**STAFF REPORT  
PLANNING MANAGER DECISION**

FILE NO.: DR-22-09

REQUEST: Approval of a Class I Historic Design Review at 1611 6<sup>th</sup> Ave

**CAD Drawing**

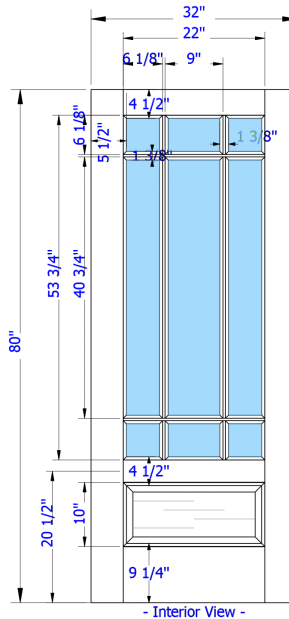
**Staff Finding 8: Staff accepts applicant’s findings in Exhibit PD-1. As detailed in the application, the proposed will retain the same material, proportions, trim, and original historic appearance. This standard is met.**

## West Side Window

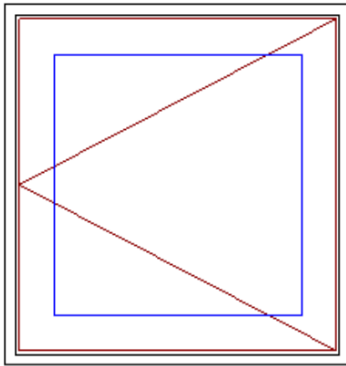
**Staff Finding 7: Staff accepts applicant’s findings in Exhibit PD-1. As detailed in the application, the windows are consistent with the original historic appearance and will retain the same proportion, trim, and color. As the windows are fixed and the need is for greater air circulation for a subterranean ADU, the original method of operation and material is not practicable. This standard is met.**
